ROTAX 503 UL DCDI (Serie), "B" - Getriebe Montage

ROTAX 503 UL DCDI (all versions), "B" type gearbox installation

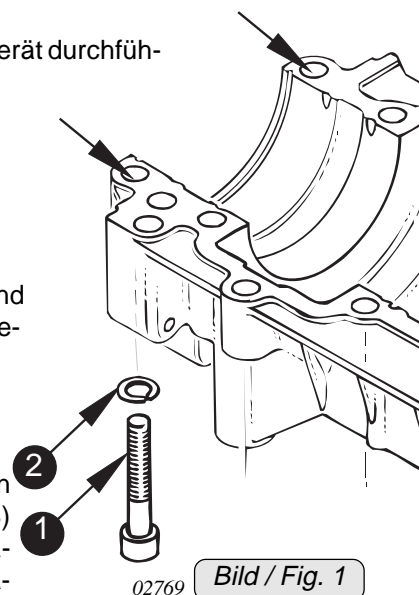
Aufgrund der Standardisierung wurde die Lage der vorderen Gehäuseschrauben (siehe Bild 1) geändert. Die beiden Schrauben (T.Nr. 841.561) wurden durch die Schrauben (T.Nr. 640.611) ersetzt.

In the course of standardization the location of the front crankcase fasteners (see fig. 1) has been changed. The two screws (part no. 841.561) have been replaced by the screws (part no. 640.611).

■ **ACHTUNG:** Die Verwendung der Schrauben (T. Nr. 841.561) in Verbindung mit dem neuen Gehäuse (T. Nr. 887.798) könnte bei der Montage eines "B" Getriebes Beschädigungen am Getriebedeckel hervorrufen, und ist daher nicht zulässig.

■ **Attention:** Use of the screws (part no. 841.561) on the new crankcase (part no. 887.798) could result in damage of gear cover at installation of a "B" type gearbox. Therefore employment of these screws is not permitted.

- Die beiden Schrauben (1) entfernen.
- Neue Schrauben mit neuem Federring (2) einschrauben und mit geeigneten Werkzeug (6 DIN 6911) mit 22 Nm festziehen.
- Getriebe gemäß Service Information SI 12 UL 94 montieren.
- Motorprüflauf durchführen.

The Allen screws (part no. 841.561) have to be replaced by the Allen screws (part no. 640.611) if a "B" type gearbox is going to be fitted.

- Remove the two screws (1).
- Fit the new type screws along with lock washer (2) using Allen key (6 DIN 6911) and tighten to 22 Nm (195 in.lb).
- Install gearbox as per Service Information SI 12 UL 94.
- Conduct engine test run.
